ADDENDUM NO. 1

<u>CROSS OAK DRIVE, FORTUNATE PLACE, REDAN DRIVE AND</u> <u>SILICON PRAIRIE PARKWAY ASSESSMENT DISTRICT - 2014</u>

CONTRACT NO. 7224

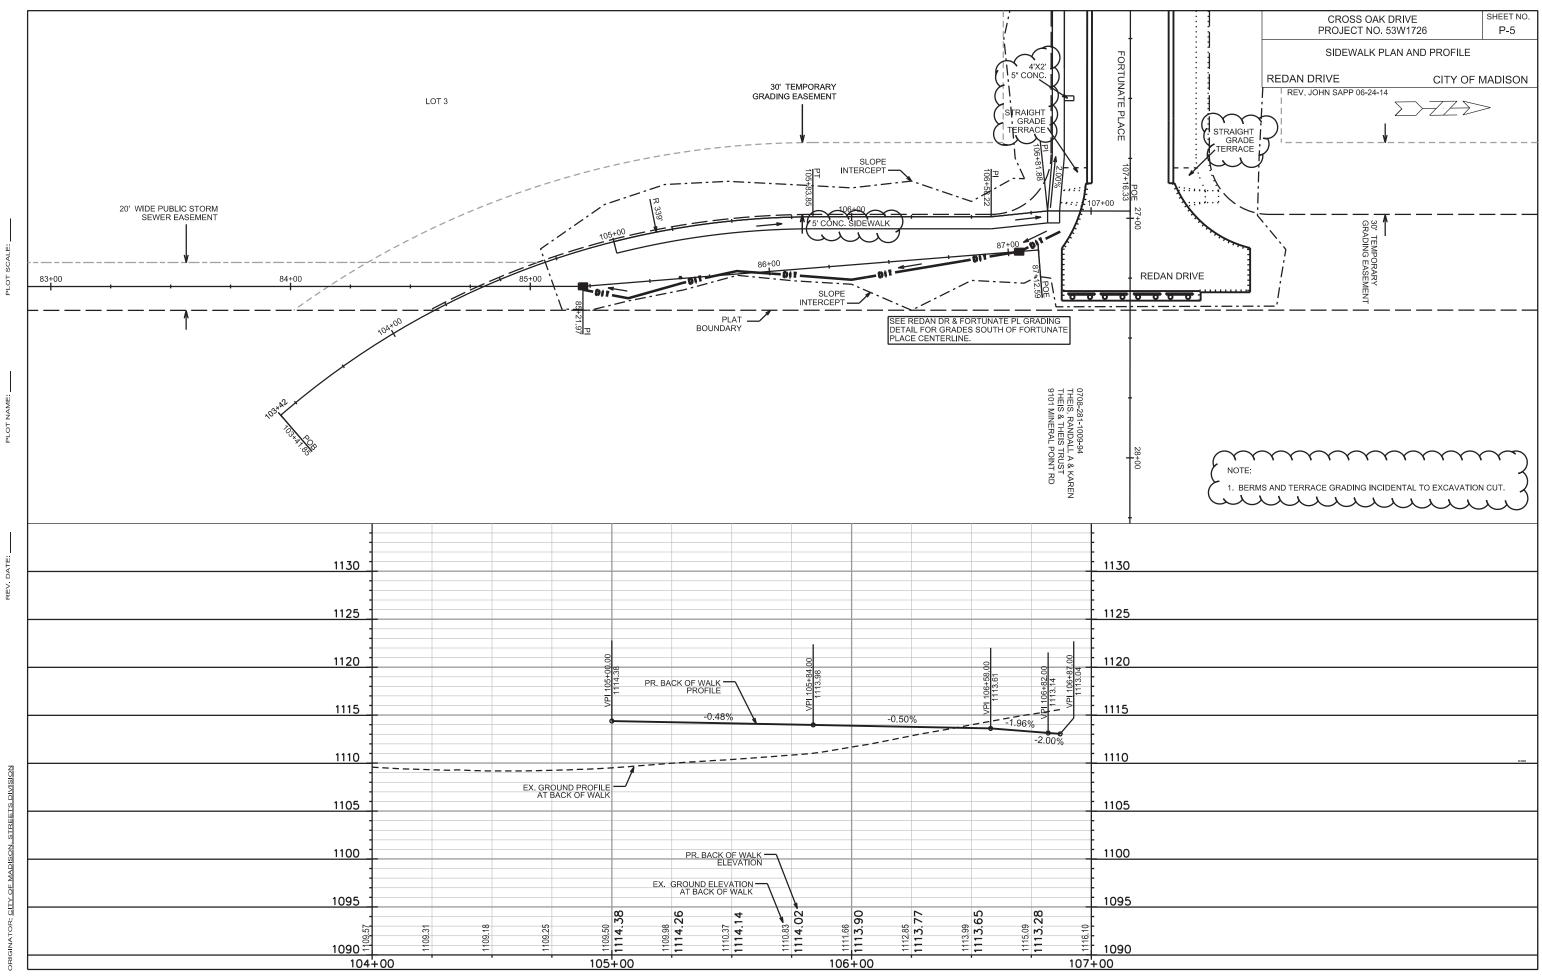
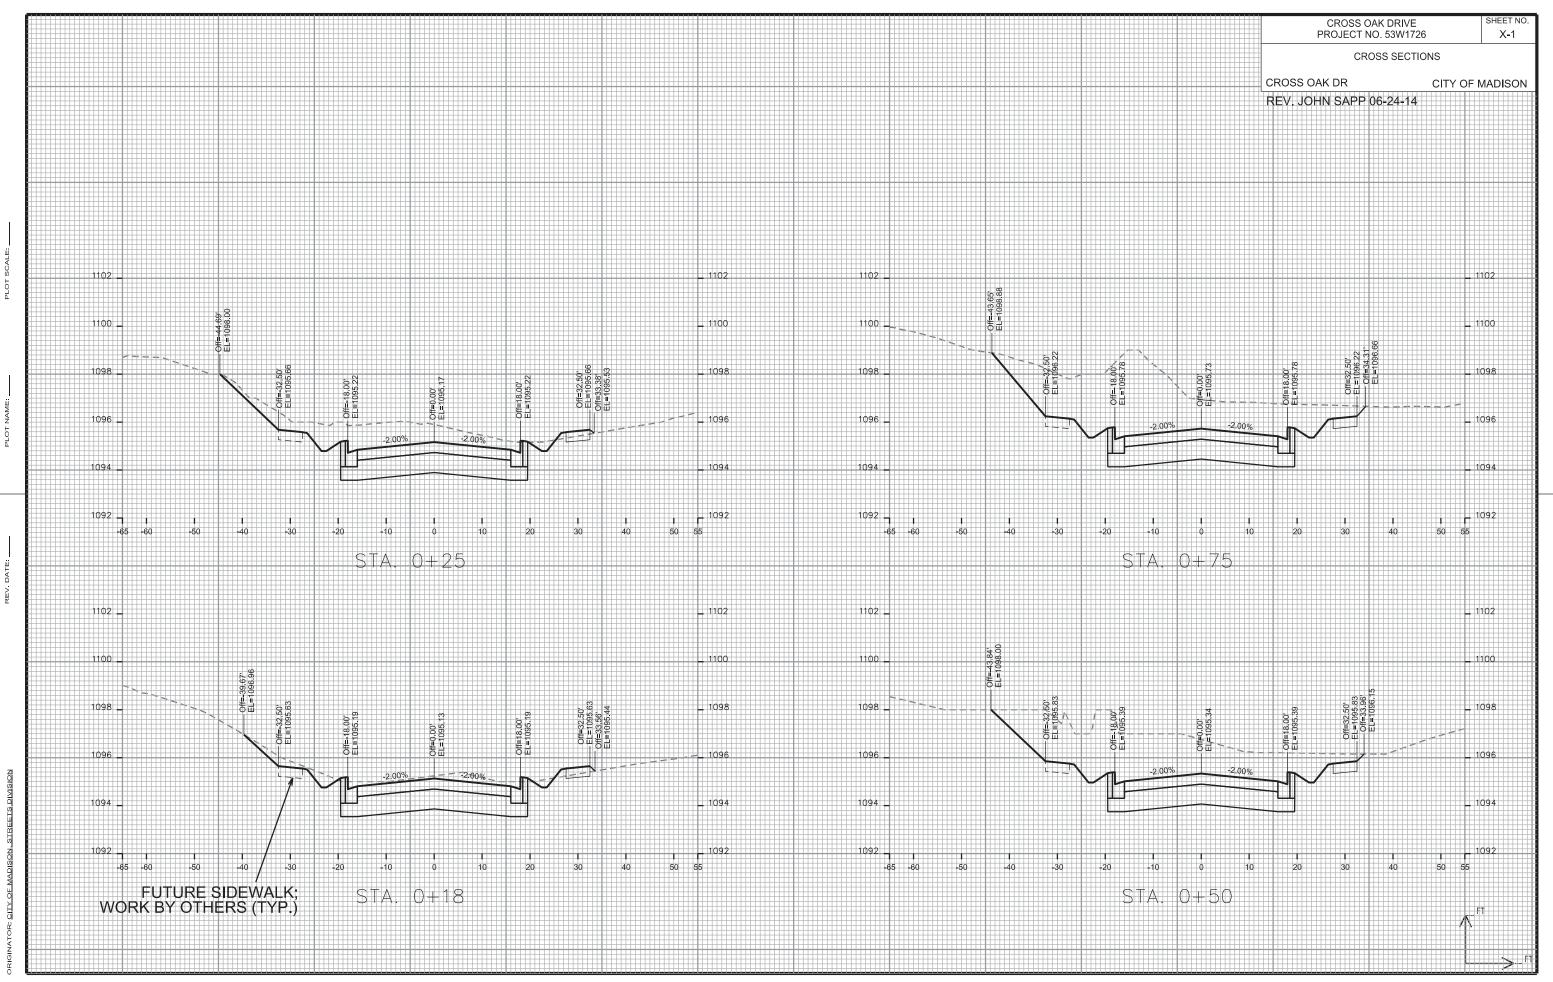
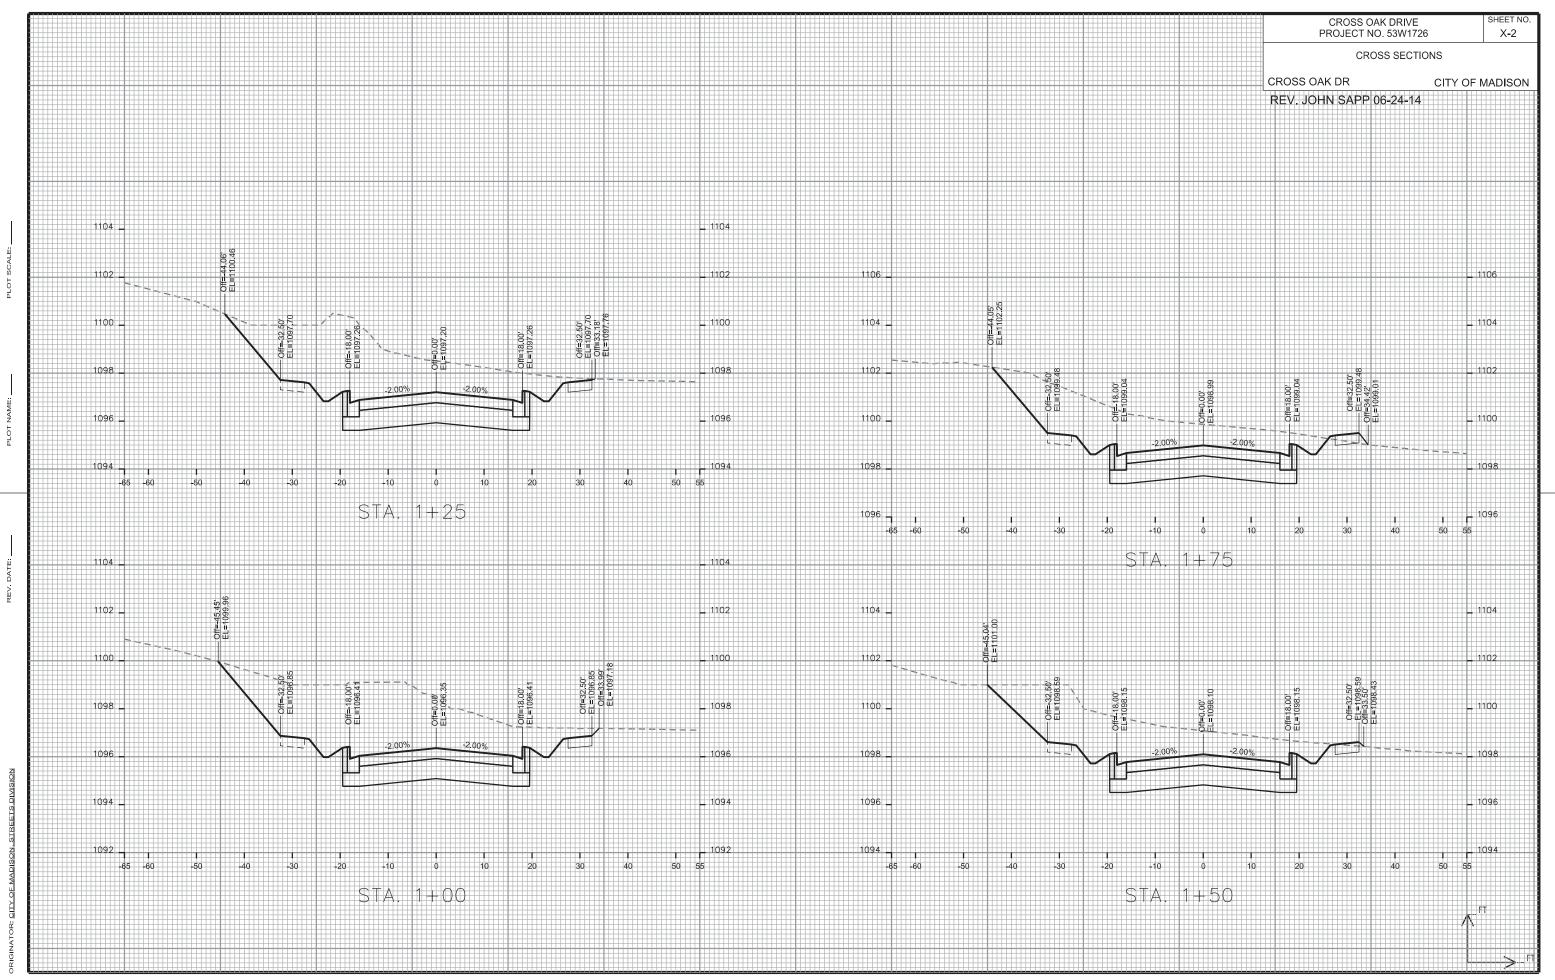
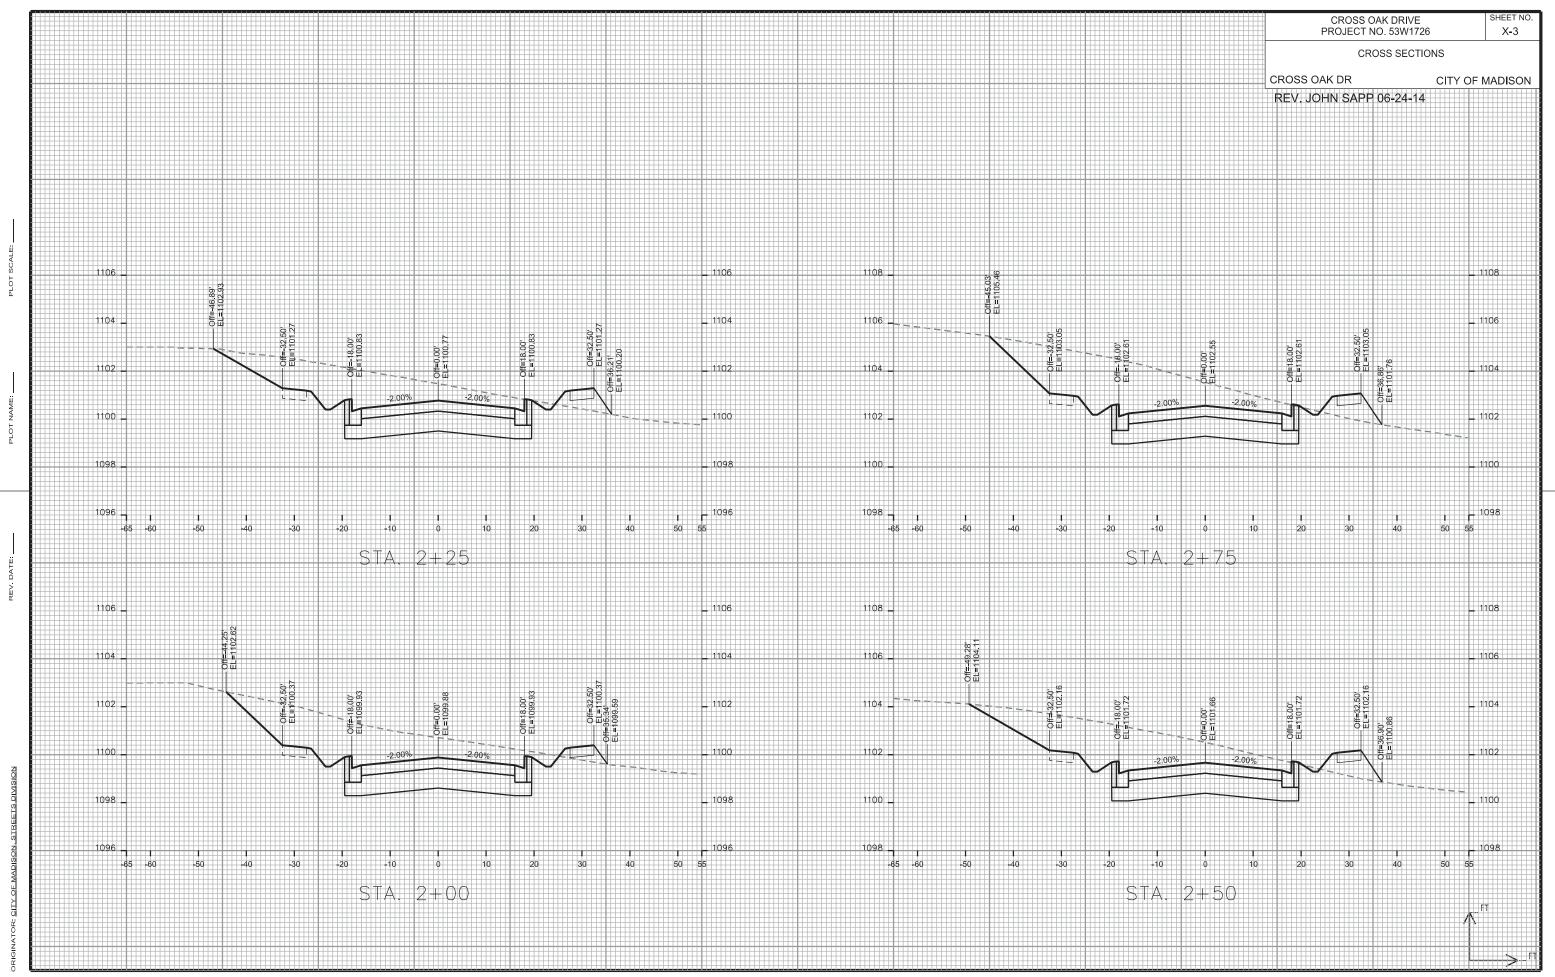
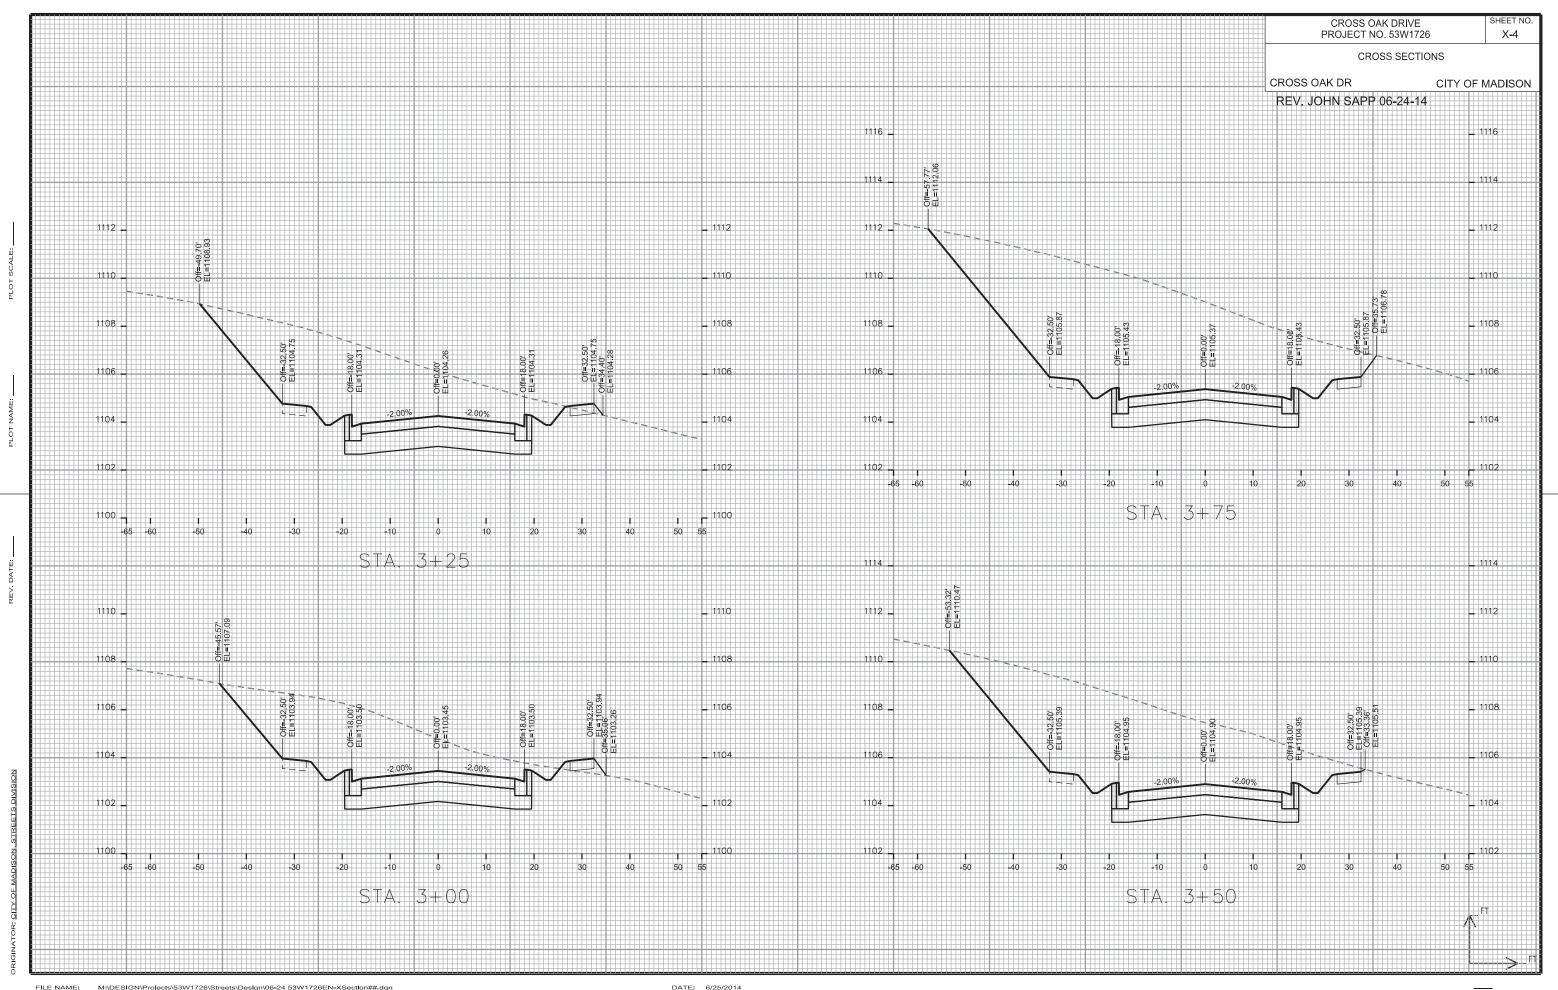
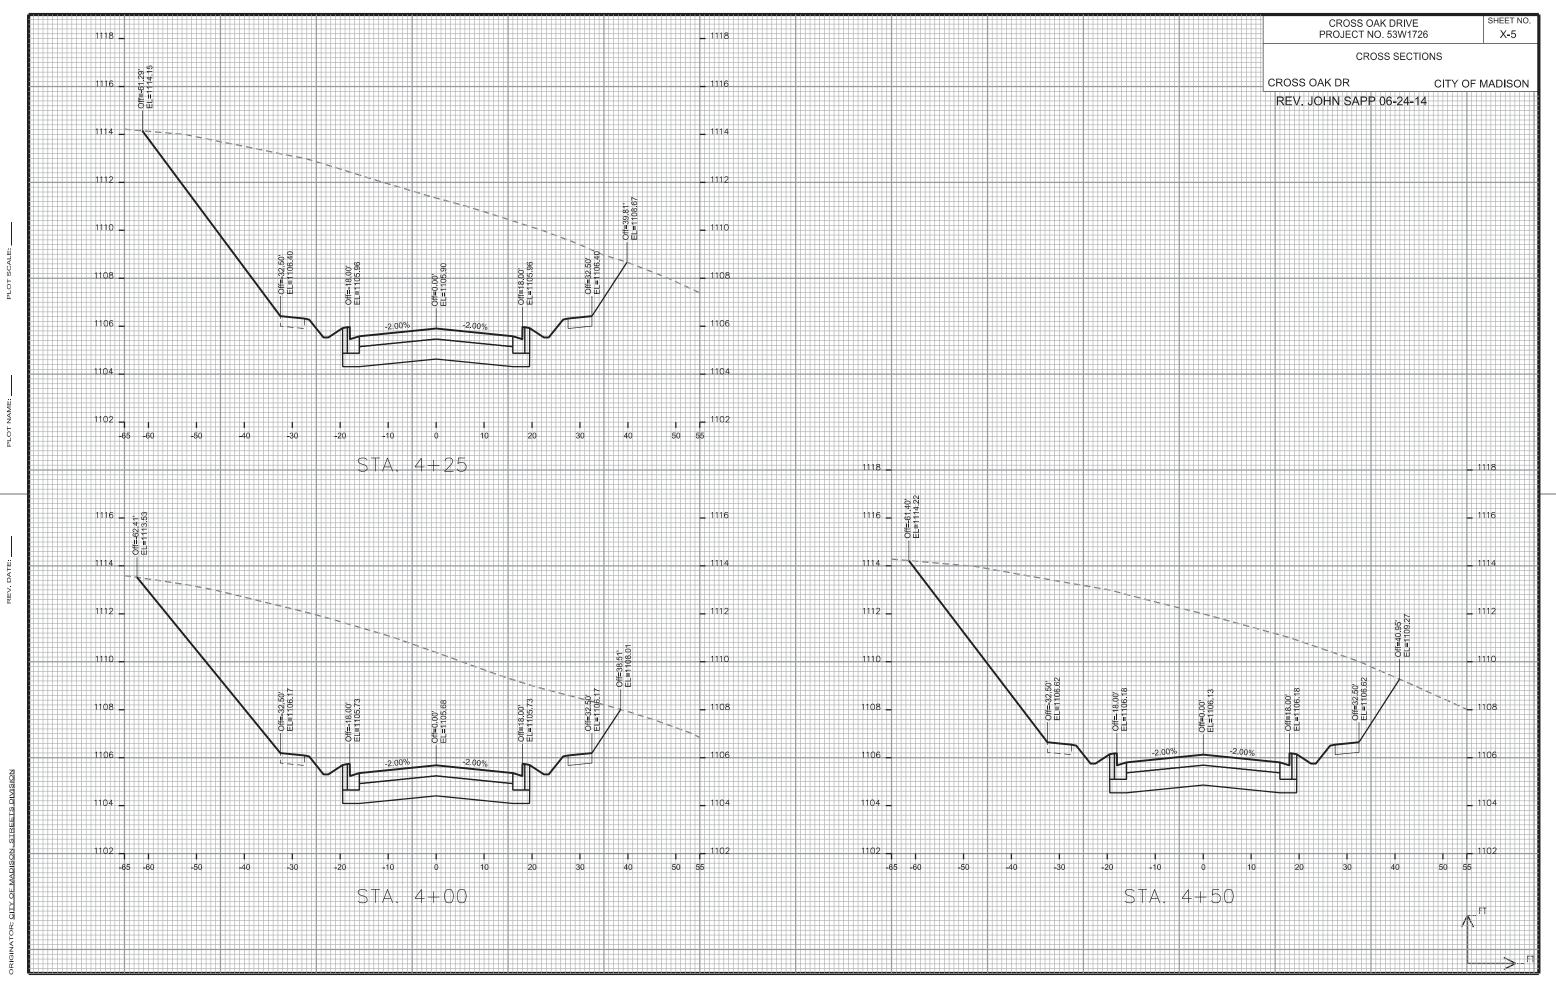
X1-X13: Cross section sheets revised to show infiltration swale within terraces.
